ADDENDUM NO. 1

PROJECT TE1817

Old Pike Road Improvements – Vivion Road to NW Englewood Road

GLADSTONE, MISSOURI

NW ENGLEWOOD ROAD
& N. BROADWAY
TRAFFIC SIGNAL

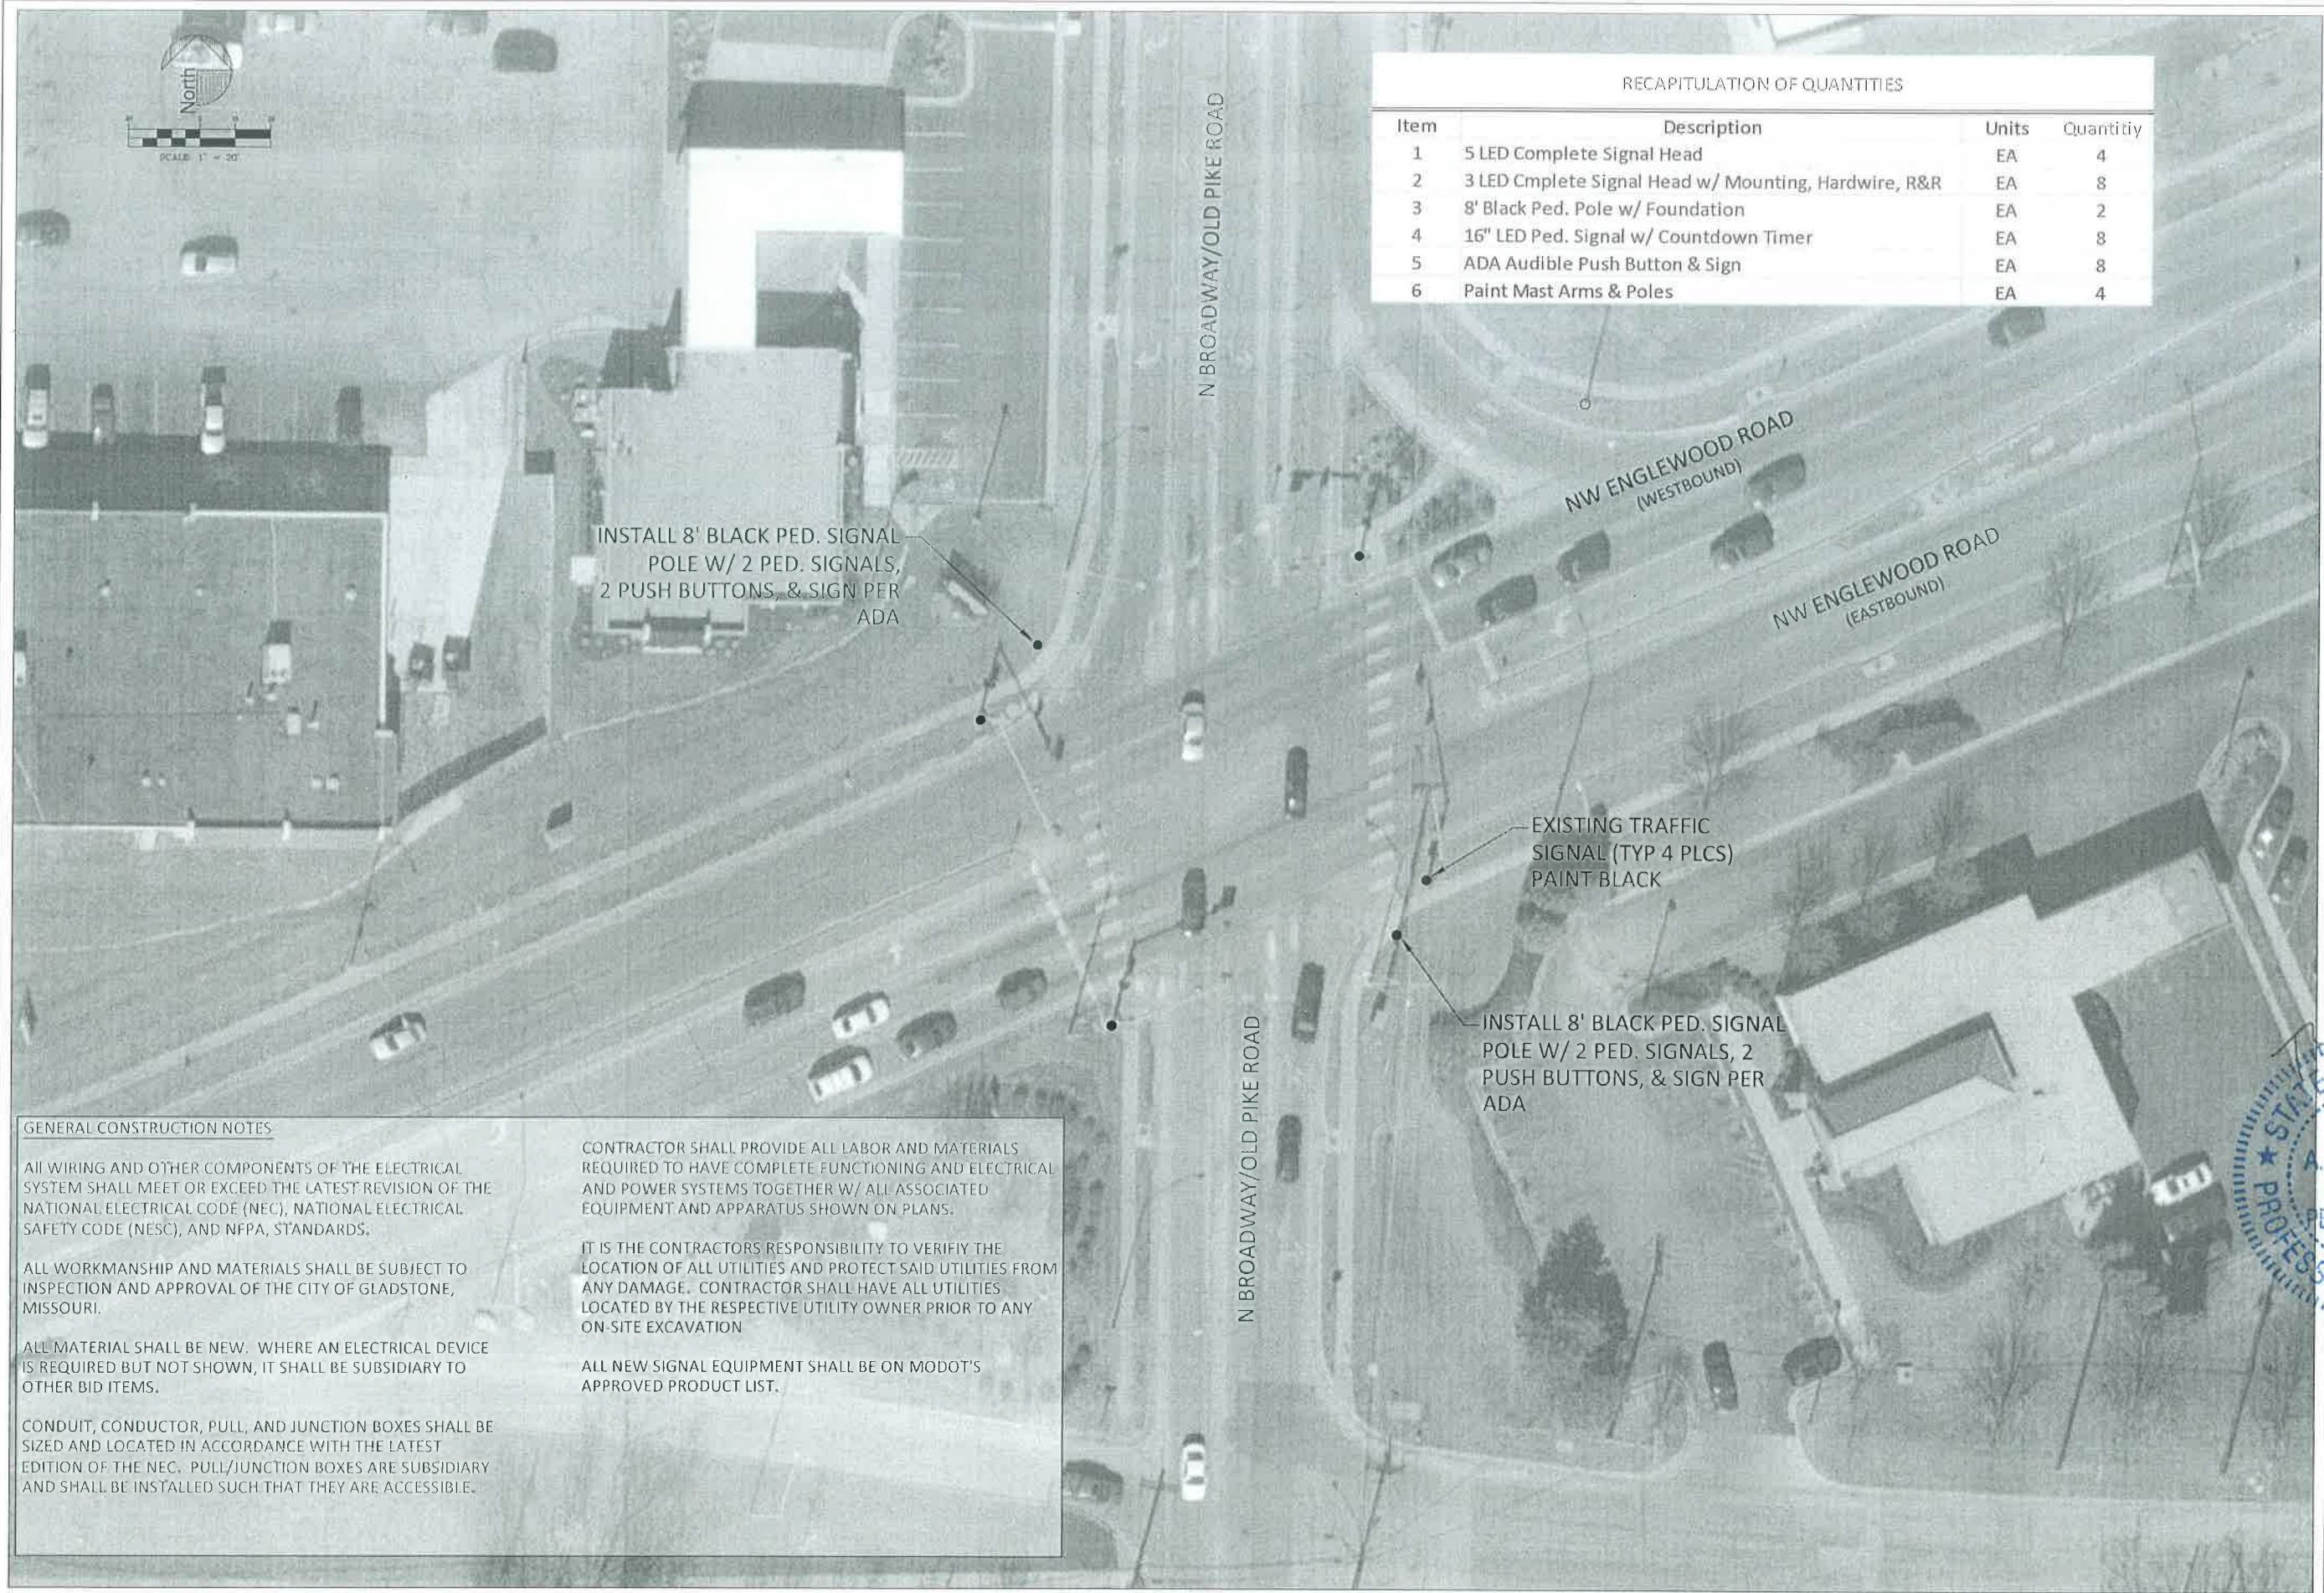
3. Add N. Broadway signal sheet.
4. Mill and Overlay:
 - a. Mobile traffic control shall be used during milling and paving operations and shall conform to MUTCD detail TA-17.

SHEET NUMBER
33

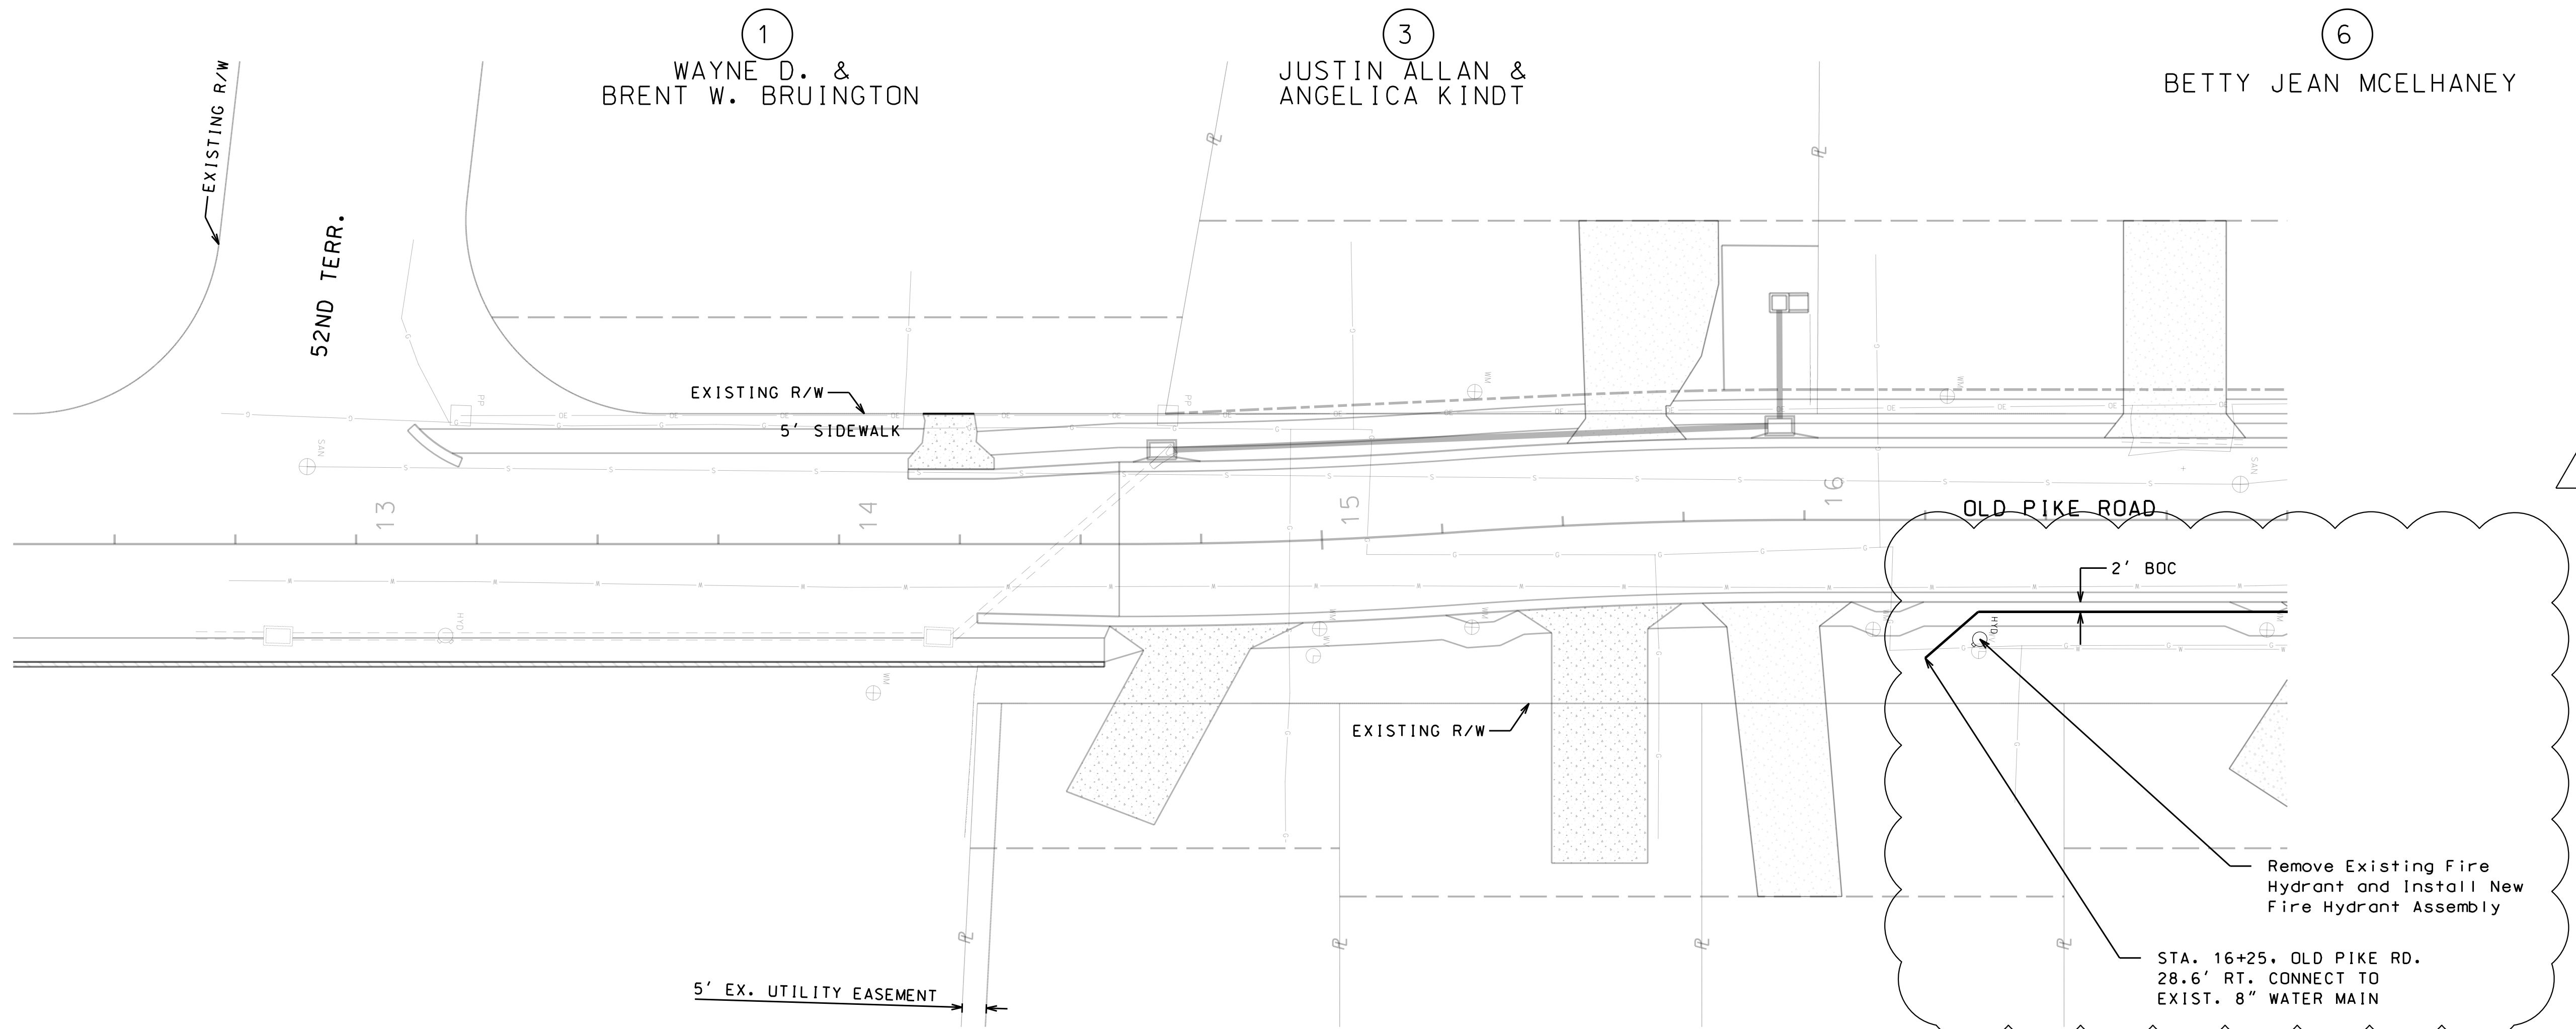
- b. Landscaping items, including seed and sod, shall be completed by November 15, 2019.
2. Replace Sheets 33 and 34 with the attached drawings. Begin the 8-inch water main relocation on Sheet 33 at Sta. 16+25, 28.6'-Rt and install a new fire hydrant. Field verify the elevation of the existing main prior to beginning work. The unit price of the fire hydrant assembly shall include the tee, valve, and fire hydrant.

NEW FIRE HYDRANT ASSEMBLY		
STA.	OFFSET	SIDE
16+36.32	24.69	RT.
